PARTS & SERVICE NEWS

REF NO. AA03087A

SUBJECT:	830E LADDER HANDRAIL INTERFERENCE AND VISIBILITY PROBLEMS
PURPOSE:	To inform the field of an upgrade kit for 830E ladder handrails.
APPLICATION:	Komatsu 830E Dump Trucks A30662, A30677 - A30696
FAILURE CODE:	54L0PC
DESCRIPTION:	Ladder Handrail Upgrade Kit (XK0205)

FIGURE 2. NEW 830E LADDER HANDRAILS

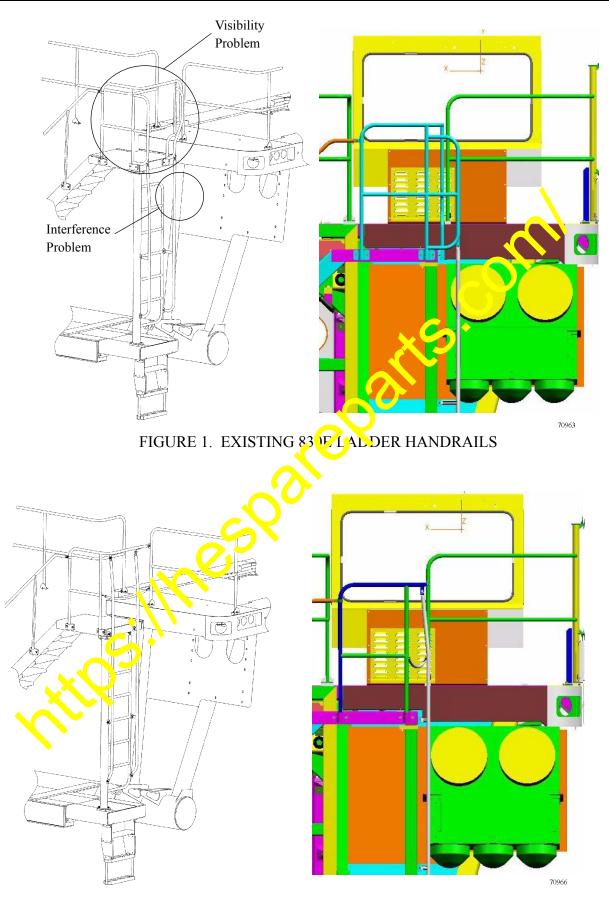
The handrail on the ladder interferes with the removal of the LH inboard air cleaner filter element on some 830E dump trucks. Visibility may be obstructed due to the number and positions of handrail posts located around the upper diagonal ladder platform. Refer to Figure .

In order to eliminate the interference problem and improve visibility a new kit (XK0205) has been developed to replace some of the handrails. The handrails have been noved closer to the ladder post, providing clearance for air cleaner filter element removal while main aining an acceptable hand clearance. The handrails surrounding the upper platform were redesioned to reduce the number of vertical posts and reposition the remaining posts such that a limited number of posts are within the operators forward view. The contents of the handrail upgrade kit are listed in Table 1. Refer to rework drawing (EK6626) for complete rework instructions. Figure 2 illustrates the new ladder handrails.
